South Texas Project Electric Generating Station P.O. Box 289 Wadsworth, Texas 77483

U7-C-STP-NRC-090022

South Texas Project
Units 3 and 4
Docket Nos. 52-012 and 52-013
Revised Responses to Requests for Additional Information

Figure 1 – HEC-HMS Hydrologic Diagram for Scenario 1

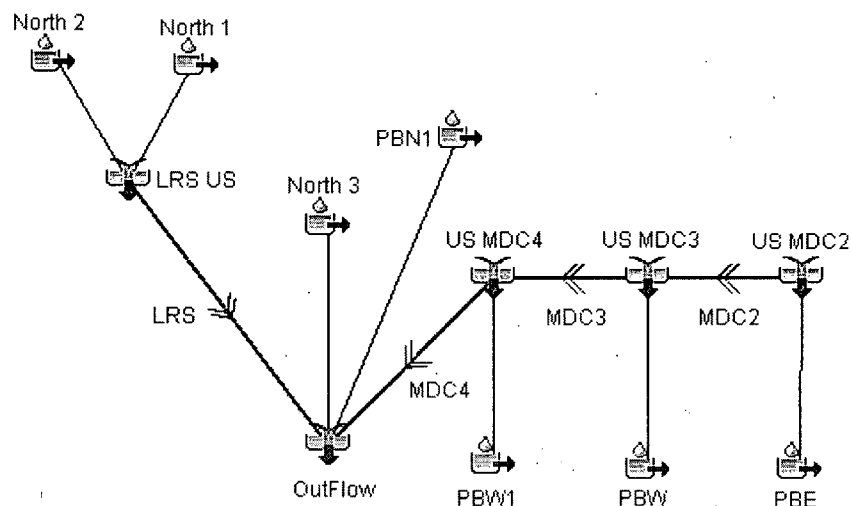
In Scenario 1, flood flow from North1 and North2 is assumed to discharge to LRS unimpeded. This is accomplished in the HEC-HMS flood routing model (Reference 1) by assigning a junction element, instead of a reservoir element as in the COLA base case, at the FM 521 crossing at LRS. The conceptual model for Scenario 1 as represented in HEC-HMS is shown on Figure 1, while the scheme for the COLA base case presented in the FSAR is shown on Figure 2.4S.2-6 of Revision 0 of the FSAR.

The HEC-HMS modeling results of the two scenarios show that Scenario 1 produces a higher flood peak at the junction of LRS and MDC (model junction "Outflow") than Scenario 2 (at model junction "Outflow"). This is primarily a result of the longer time of concentration estimated for the larger subbasin North1A, which has a longer flow path. Consequently, the predicted flood hydrograph for Scenario 1 is used to estimate the maximum water level in the power block area by using the HEC-RAS model previously developed for the COLA base case.

The HEC-HMS results for Scenario 1 show that the peak discharge from the northern subbasins (North1 and North2) that contributes to LRS (9,714.9 cfs) is higher and arrives earlier (5:25 hrs into the storm) than the peak discharge (7,690.3 cfs) and arrival time (6:25 hrs into the storm) from the COLA base case. For Scenario 1, the predicted peak discharge at model junction Outflow is 11,459.6 cfs, which is about 16% higher than the peak discharge of 9852.0 cfs from the COLA base case simulation. The arrival times of the peaks are nearly the same, 3:35 hrs and 3:40 hrs into the storm, respectively. The peak discharges and their arrival times at the subbasin outlets for the eastern subbasins (PBE, PBW, PBN1 and PBW1) remain unchanged. The

Figure 2 – HEC-HMS Hydrologic Diagram for Scenario 2

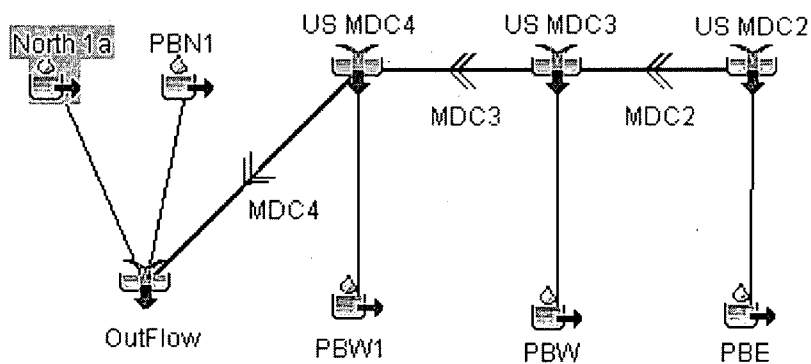
In Scenario 2, FM 521 is assumed to be completely ineffective as a flow barrier and no longer constitutes a drainage divide between subbasins North1/North2 and North3. Flood flow from the northern subbasins North1, North2 and North3, now combined to form a bigger subbasin North1A, would discharge to MDC at its junction with LRS. The conceptual model of Scenario 2 as represented in HEC-HMS is shown on Figure 2.

Figure 3 – Precipitation Distribution and Resulting Runoff for Subbasin PBN1

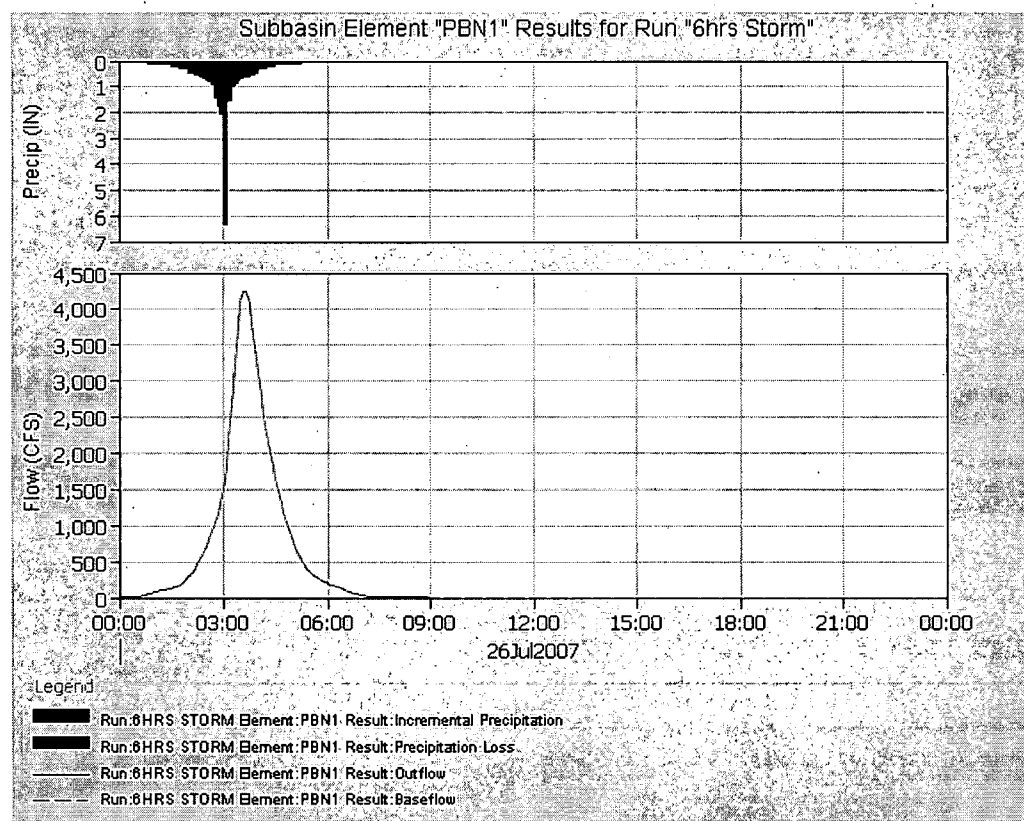
RAI Part 2: Provide justification for using a 6-hr PMP, rather than using a shorter duration and more intense PMP value, to obtain a peak PMF water level in the power block area.

The 6-hr PMP storm used as input to the HEC-HMS flood model is represented by PMP rainfall depths of 5 min, 15 min, 1 hr, 2 hrs, 3 hrs and 6 hrs durations as shown in Table 2.4S.2-4 of Revision 0 of FSAR. The effect of the more intense PMP values corresponding to shorter duration events, down to a 5-minute duration, on the water level in the power block area have been captured in the HEC-HMS and HEC-RAS analyses. Figure 3, which shows the distribution of precipitation intensities and resulting runoff hydrograph for the subbasin PBN1, is provided as an example.

Figure 1 – PBE Local PMP Flood Hydrograph

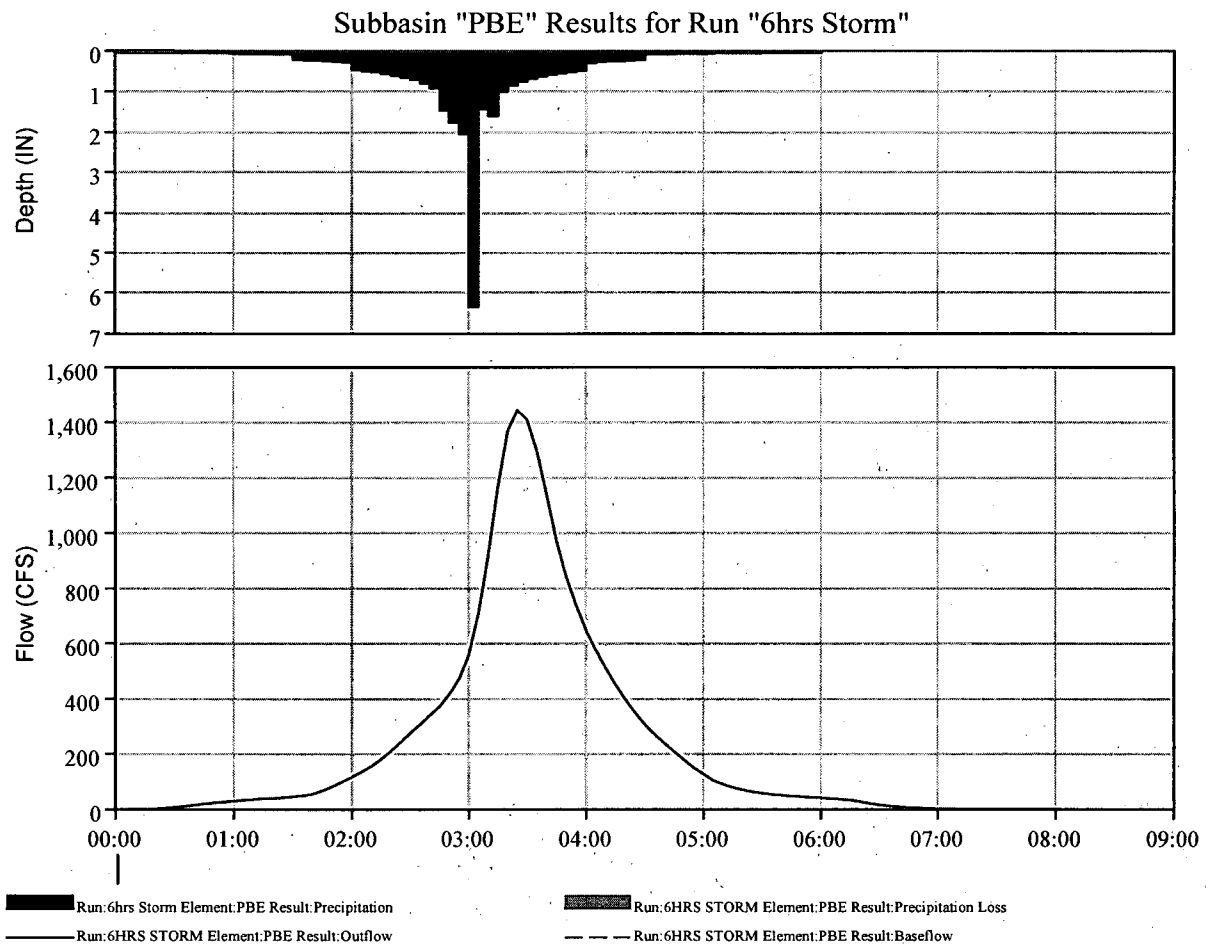
Section C.I.2.4.10 of Regulatory Guide 1.206 specifies that “the applicant should describe the static and dynamic consequences of all types of flooding on each pertinent safety-related facility.” Also, Section C.I.2.4.14 states that “if the applicant will use emergency procedures...appropriate water levels and lead times available should be provided. The applicant should develop specific details on ... (2) the amount of time available to initiate and complete emergency procedures” To meet the above requirements, provide, in addition to severe flooding levels, other flooding parameters such as flow velocity and duration (beginning, peak, and ending) of inundation important for design of safety-related SSCs and preparation of emergency procedures.

The duration of the local PMP flood level is estimated from the local PMP hydrographs for the east and west power block drainage areas (PBE and PBW) shown in Figures 1 and 2. As shown in these figures, the duration of the entire runoff hydrograph is approximately 7 hours. The duration of flood flows above 1,000 cubic feet per second lasts less than 1 hour, and less than 3 hours for flood flows above 200 cubic feet per second for both the east and west drainage channels. The local PMP event is also a slow moving event providing time for action by plant operators.
